GMU Project 17-206-02
Permit No. PKG21-0490

Subject: Response to County of Orange Geotechnical Review Comments Pertaining to Precise Grading Plans, Dana Point Harbor Revitalization, Buildings 1 through 12, Commercial Component, City of Dana Point, California

GMU	Project Name Dana Point Harbor Commercial Component Project No. 11-161-00	**Integrated SPT Method for Estimating Subsurface Stratification & Liquefaction** **Drill Hole DH-19**

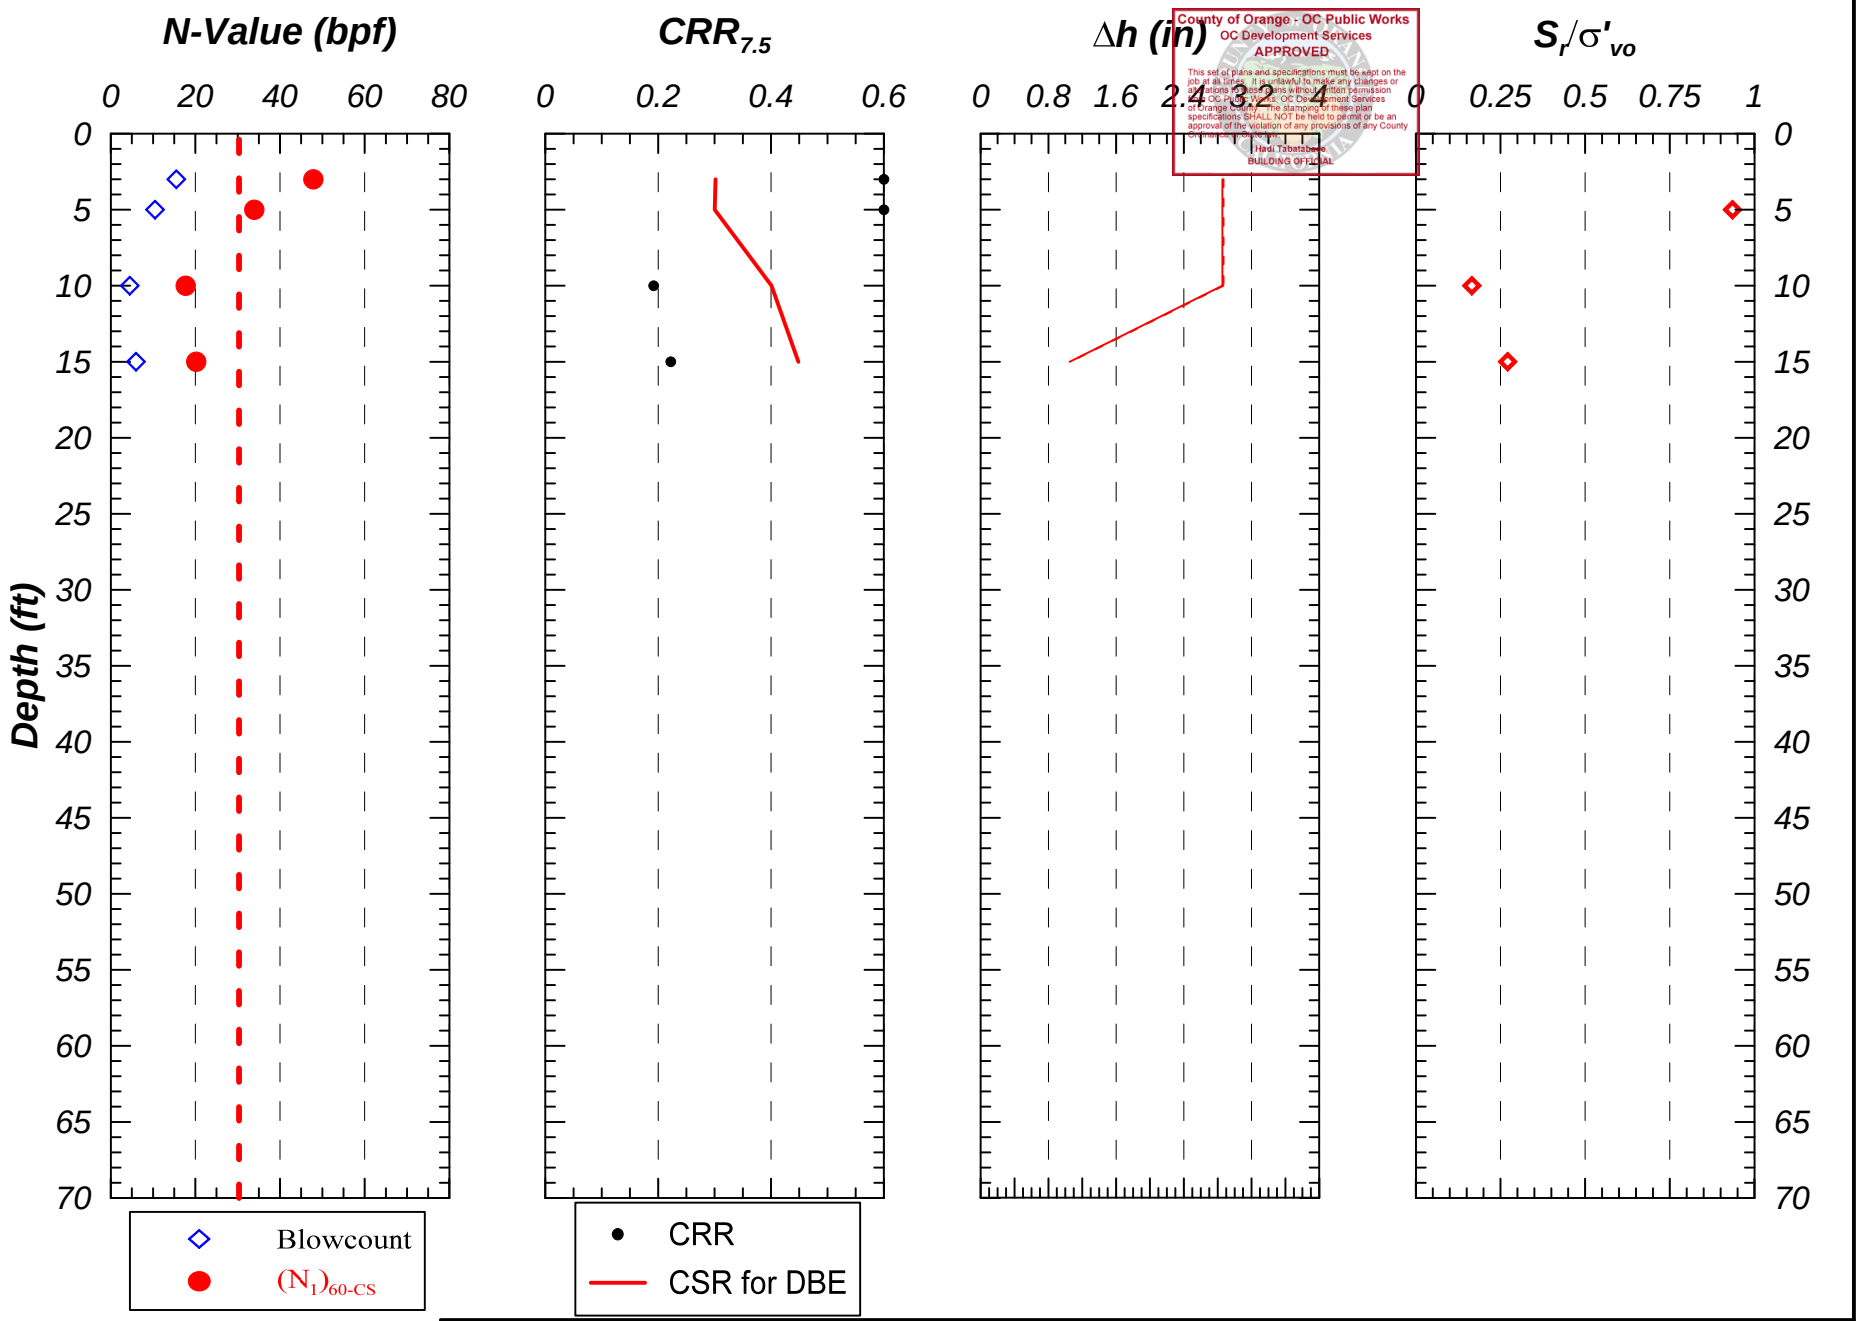
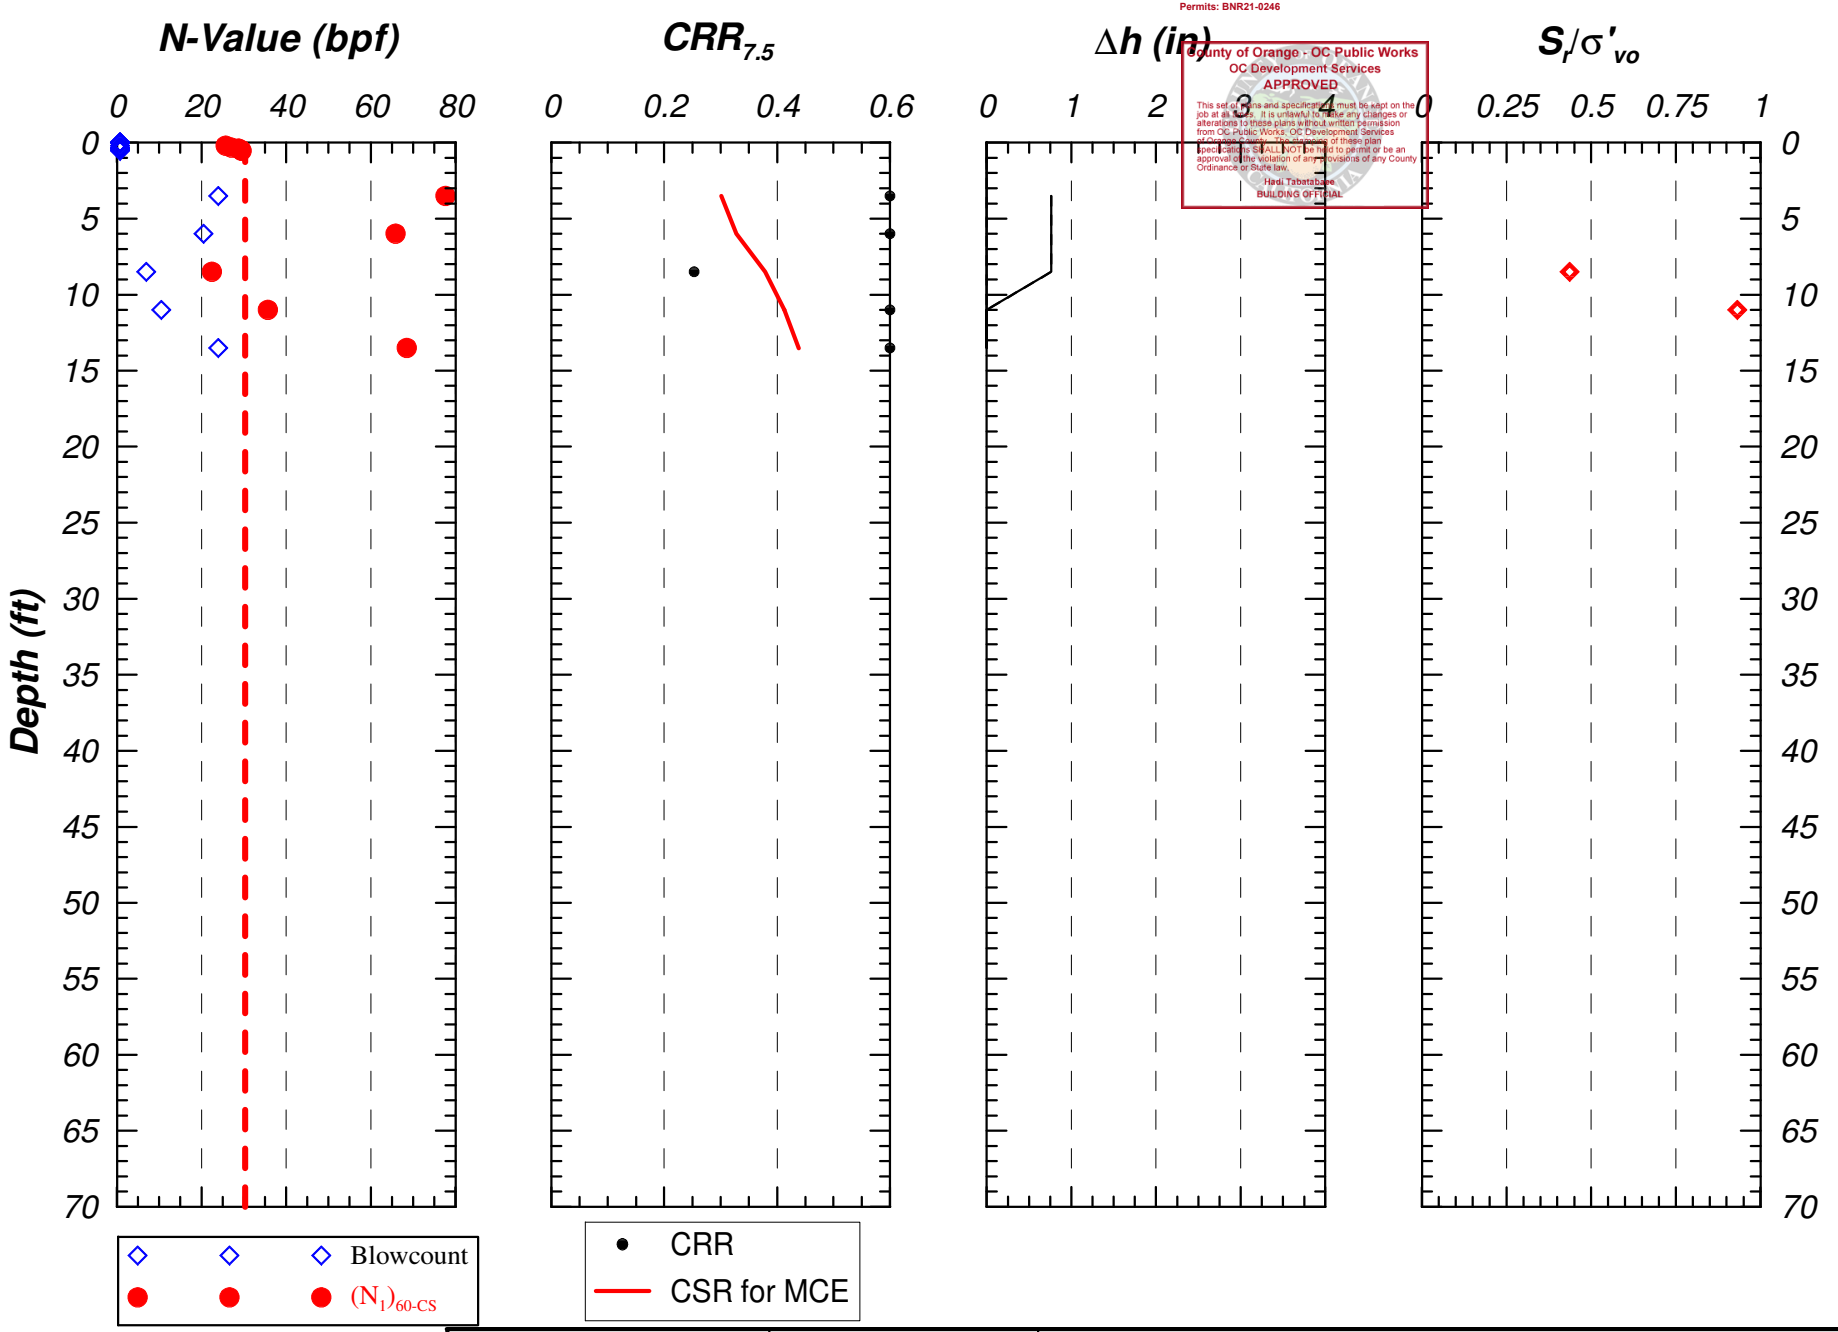
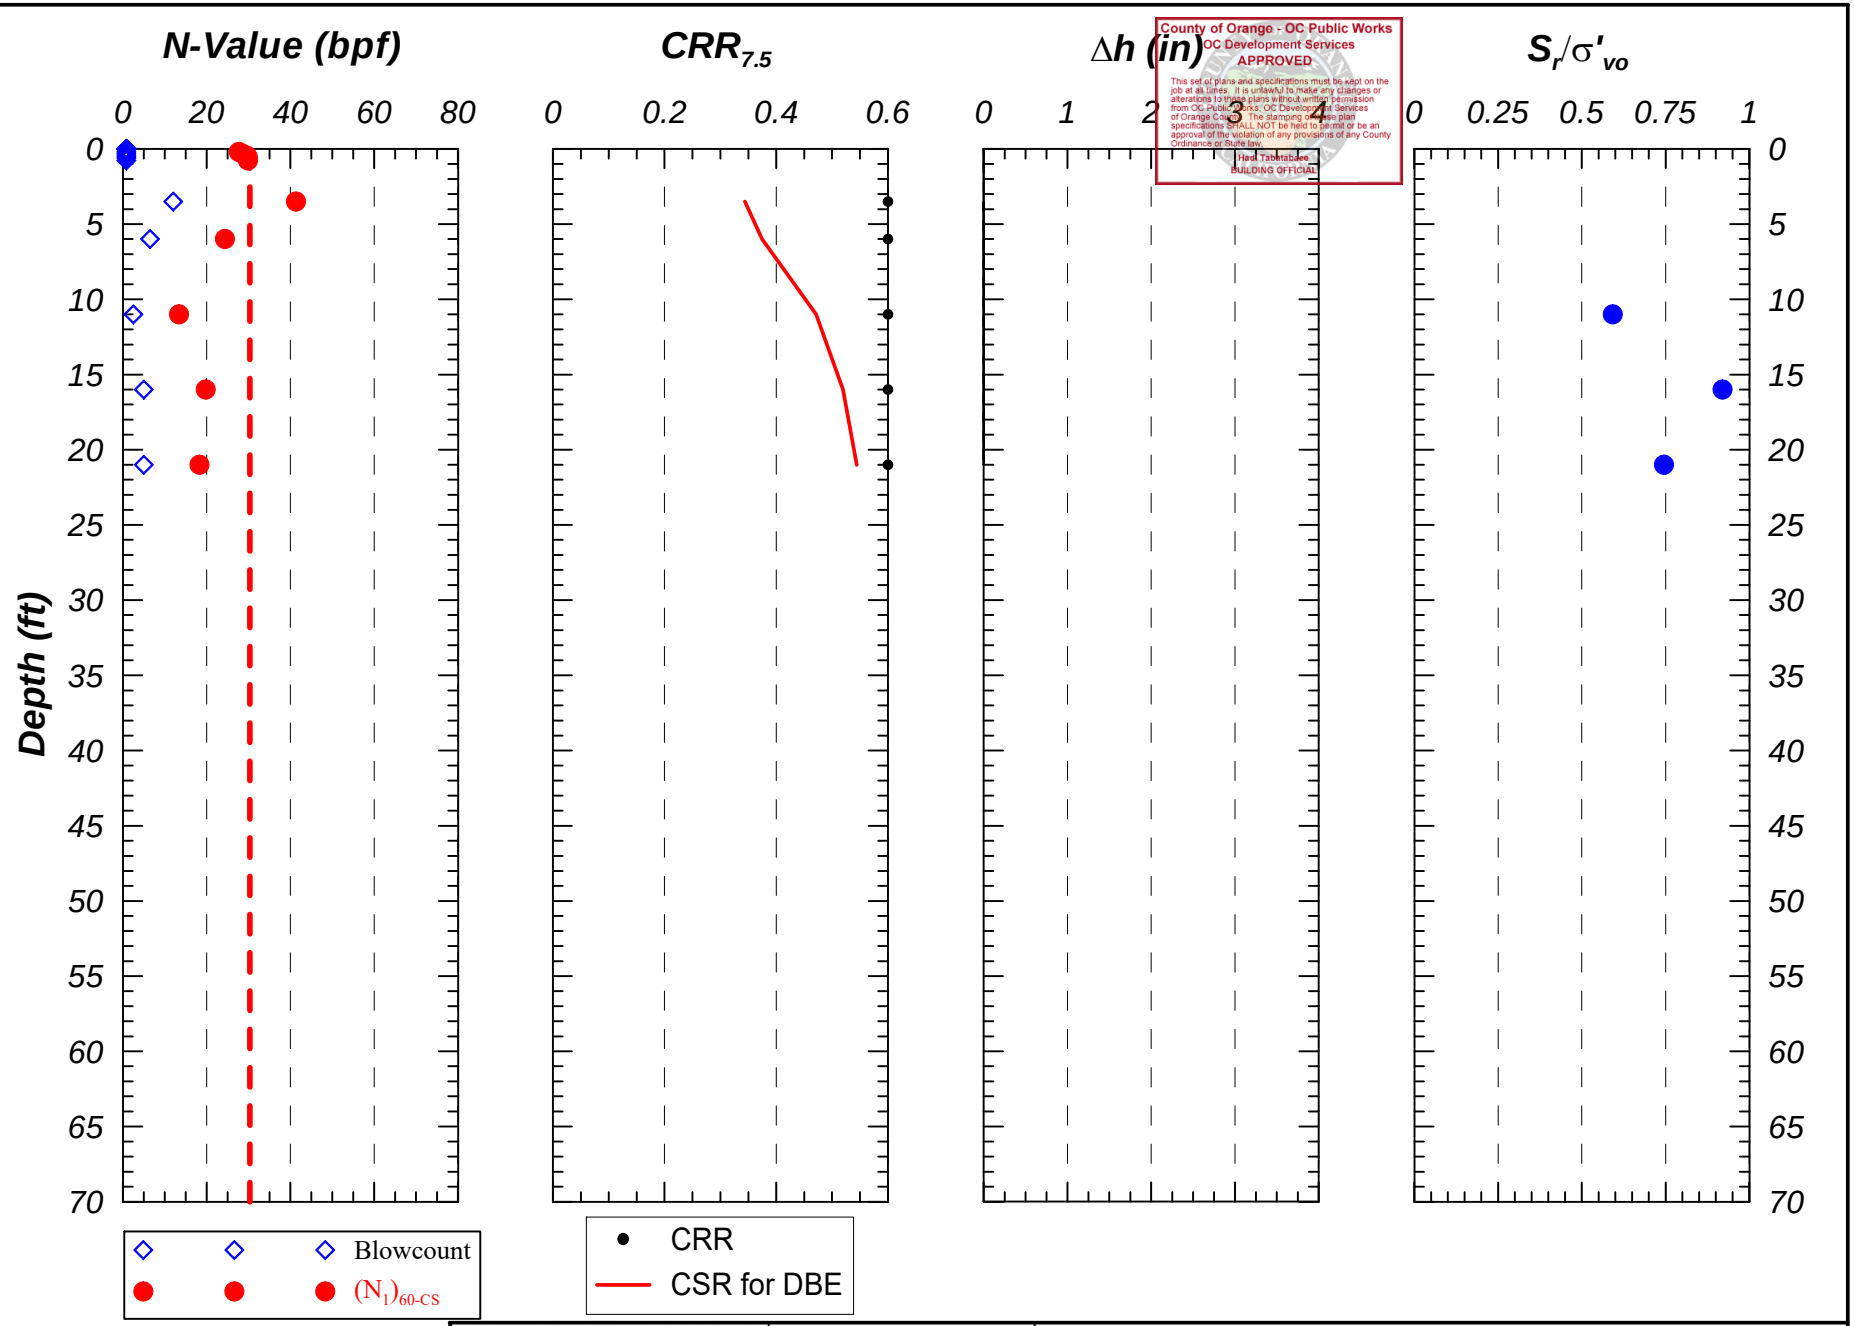
The submitted geotechnical report (GMU Geotechnical, Inc., dated 5/27/21) indicates that liquefaction analysis was performed on the SPT exploratory data as a cross-check to the CPT liquefaction analysis and yielded similar results. Please provide a copy of the completed SPT liquefaction analysis as discussed in the submitted report. Provide additional recommendations as needed.

Results of the liquefaction analysis performed on SPT data of six (6) exploratory borings (DH-12, DH-17, DH-18, DH-19, DH-26, DH-51) are included as Appendix B. As stated in the submitted geotechnical report, CPT-based liquefaction analyses provide a more reliable, accurate and continuous database from which to calculate liquefaction magnitude. The SPT-based analysis was generally consistent with the results of the CPT-based analysis, but it does include a few isolated cases indicating a larger magnitude of settlement, which is not uncommon using SPT-based analysis. We do not believe these aberrations are accurate predictions of the expected earthquake-induced settlements under the considered ground motions.
